Staff Summary Report

SUBJECT: Hold a public meeting for a Development Plan Review for SSI INDUSTRIAL BUILDING located at 1861 East 3rd Street.

COMMENTS: Request for **SSI INDUSTRIAL BUILDING (PL080295)** (James Phillips, Phillips Architects, applicant; Third Street LLC, property owner) consists of site plan, landscape plan and building elevations for a new 15,000 s.f. building on 0.63 net, located at 1861 East 3rd Street in the GID, General Industrial District . The request includes the following:

DPR09029 - Development Plan Review including site plan, building elevations and landscape plan for new building.

SITE PLAN
SCALE 1" = 20'

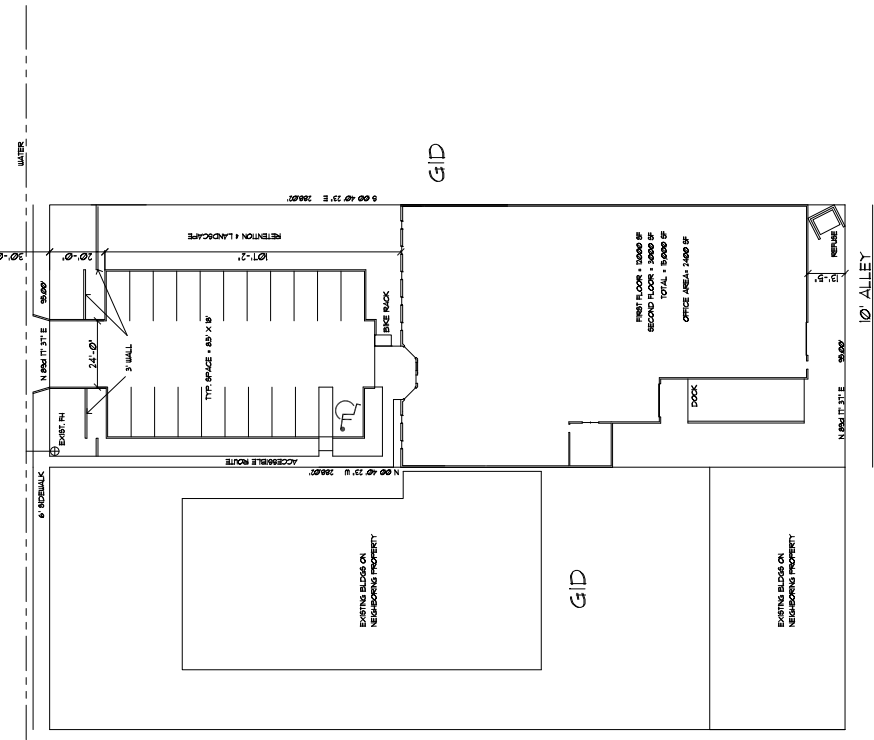
1. Utility equipment boxes for this development shall be finished in a neutral color (subject to utility provider approval) that compliments the coloring of the buildings.
2. Accessible Parking spaces shall be relocated to a location that is closest to the sidewalk leading to building entrance.
3. Place exterior, freestanding reduced pressure and double check backflow assemblies in pre-manufactured, pre-finished, lockable cages (one assembly per cage). If backflow prevention or similar device is for a 3" or greater water line, delete cage and provide a masonry or concrete screen wall following the requirements of Standard Detail T-214.

A-3

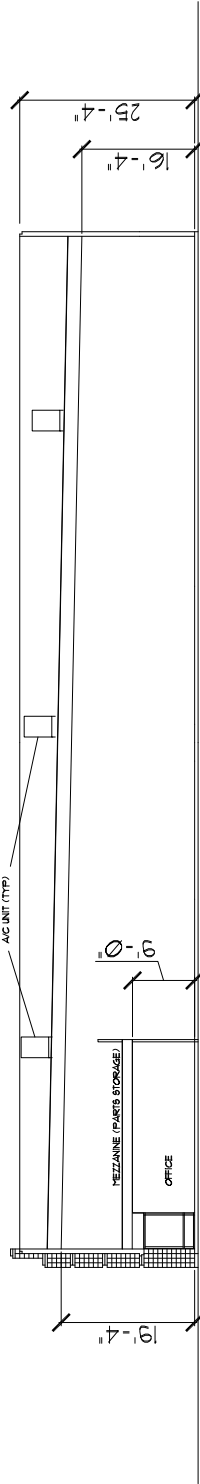
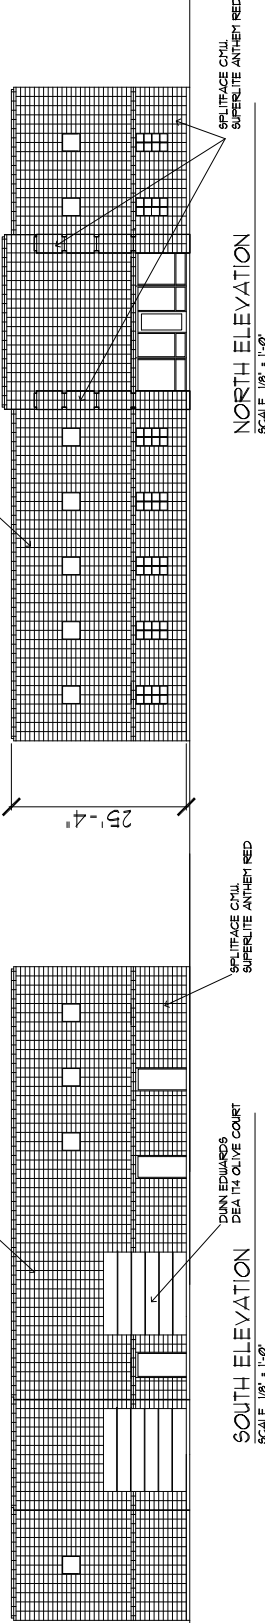
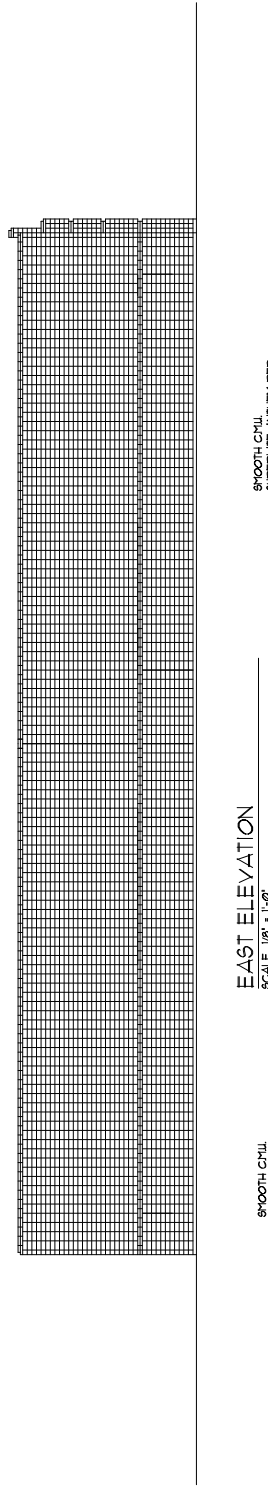
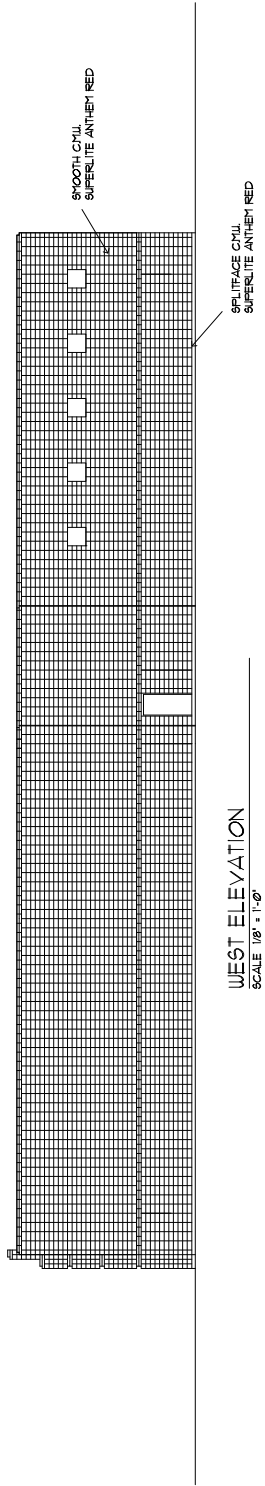
5. The materials and colors presented are approved as presented:
Primary building – Superlite “anthem red” split faced CMU and smooth block
Doors – Dunn Edwards “DE174 olive court”
Glazing – Reflective Bronze
Specific colors and materials exhibited on sample board are approved by planning staff. Submit any additions or modifications for review during building plan check process. Planning inspection staff verifies colors and materials during the construction phase.

6. Provide secure roof access from the interior of the building. Do not expose roof access to public view.
7. Incorporate lighting, address signs, incidental equipment attachments (alarm klaxons, security cameras, etc.) where exposed into the design of the building elevations.

11. All mechanical equipment shall be fully screened by a parapet.
